Comprehensive Response to Reviewer Comments (RC1–RC3) and Editorial Decision (11 April and 3 June 2025)

The Technical note: Efficiency of various evaporation barriers for use in automated water samplers for subsequent water isotope analysis by Mueller, Pekarev, and Knoeller evaluate in two experiments evaporation minimizing closers.

Technical note: Efficiency of various evaporation barriers for use in automated water samplers for subsequent water isotope analysis

Figure 1: A First experimental setup using an oven for temperature changes; B: O-rings show brittle spots due to the high temperature fluctuations

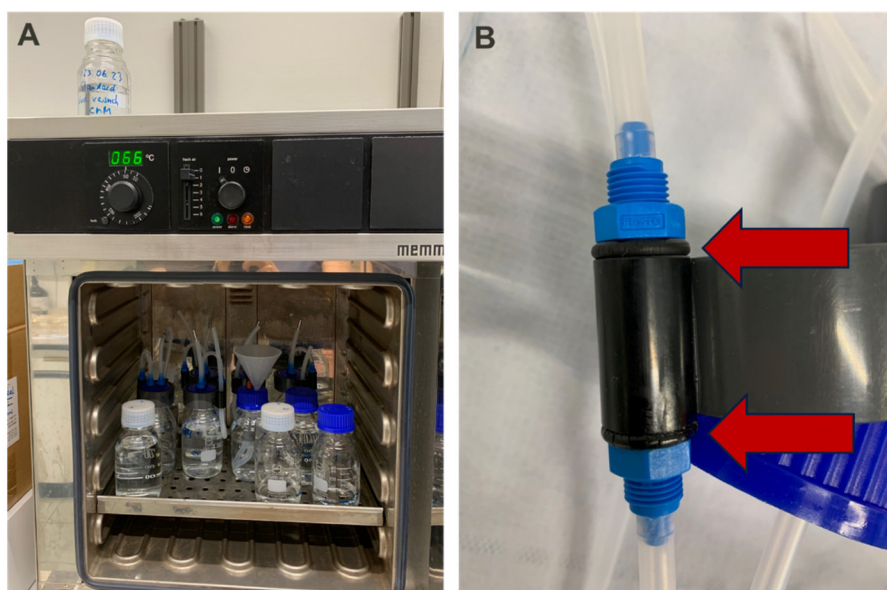
- 1) *Consider performing an additional experiment with different tube-dip-in diameters, as this was a point raised by R1*

- 2) *Additional experiments with different temperatures*

We also find this approach very interesting. However, in our experiment, the tubing diameter was not varied. The primary reason is that the connectors used were specifically designed for the selected tubing size (visible in Figure 1B) and changing them would not have been straightforward.

At the beginning of our experiment, we aimed to simulate high temperature changes to enlarge the evaporation pressure. We used a laboratory oven as Michelson et al. 2019 (HESS) used and set the temperature to 50°C. The final temperature shown by the device reached 66°C (Figure 1A).

However, after some time, we observed significant degradation of the O-rings, which are essential for maintaining the seal of the bottles. They became brittle and showed substantial damage (Figure 1B). We were concerned that this could lead to leaks, compromising the integrity of the results. For this reason, we decided to discontinue the use of the oven in subsequent experiments. All plastic components were replaced, and the experiment was restarted under ambient laboratory conditions.
